From: [Marlayna Doell](#)
To: [Gerard P. Van Noordennen-ext](#)
Cc: [tom.magette](#)
Subject: RE: La Crosse RCI Response Follow Up
Date: Thursday, November 3, 2022 4:51:00 PM
Attachments: [image001.png](#)

From: Marlayna Doell
Sent: Wednesday, October 26, 2022 1:04 PM
To: Gerard P. Van Noordennen-ext <gpvannoordennen-ext@energysolutions.com>
Cc: tom.magette <tom.magette@gmail.com>
Subject: La Crosse RCI Response Follow Up

We have had a chance to review the RCI responses from last week for the La Crosse Class 1 FSSR review and wanted to provide some feedback. The responses to the second part of RCI 1 regarding the statistical test for L1-SUB-CDR, RCI 2a, and RCI 2c are sufficient to confirm the staff’s

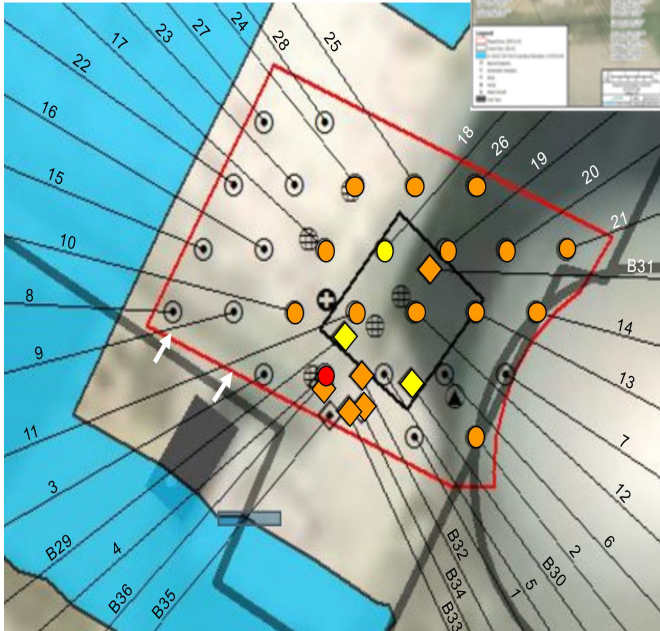
2. LATERAL EXTENT: There is a reasonable degree of certainty that the area of elevated contamination did not extend outside of the red boundary in the figure below, nor that the nearby excavation and survey activities would have the potential to spread contamination outside the originally identified area (i.e., into other survey units).

Given that the RPGPA was backfilled before GeoProbe sampling, the staff needs to understand why the higher levels of contamination appear to be in the backfill portion of the elevation. The figure below shows the systematic and judgmental sample locations that exceeded MDC, and which stratum contained the maximum concentration.

- Cs-137 24.4 pCi/g (B4) adjacent to 1.2 pCi/g (B36); immediately to east are 11.1 pCi/g (B33), and 6.05 pCi/g (B32);
- RPGPA trench box 618 ftelev
- GW flow generally westward to WSW
- Water table fluctuates 620 to 630 ft AMSL
- Ground surface at the time of GeoProbe is apparently 627 ft AMSL
- Top stratum sampled at 624- 627 ft

- Above operational DCGL, top stratum (624- 627 ft elevation)
- ◆ Above MDC, top stratum (624 - 627 ft elevation)
- ◆ Above MDC, 2nd stratum from top (621 - 625 ft elevation)
- ↑ Angled GeoProbe, 20 ft "depth" from edge of building from ~639 ft AMSL was part of initial characterization

- Given that the GeoProbe sampling results containing the 24.4 pCi/g (and the nearby 11.1 pCi/g and 6.05 pCi/g) were in the uppermost stratum of the RPGPA, and assuming that at these locations that stratum was comprised of backfill, why was this level of contamination present in the backfill material? Given the steepness of the sloped walls of the RPGPA on three sides, only the GeoProbe locations immediately adjacent to the survey unit boundary would be expected to contain soil from below excavation surface in the topmost stratum (624'-627' elevation).

- The RCI response states, “The RPGPA (TDS-B) was the second unit surveyed and was backfilled prior to the survey.” The team acknowledges that groundwater was intruding into the trench box area of the RPGPA (black boxed area in the figure), but is questioning if there were any scans of the soil that was not covered in water prior to backfill being emplaced over the entire survey unit – that is, the area that is inside the red box but not in the black trench box square in the figure.
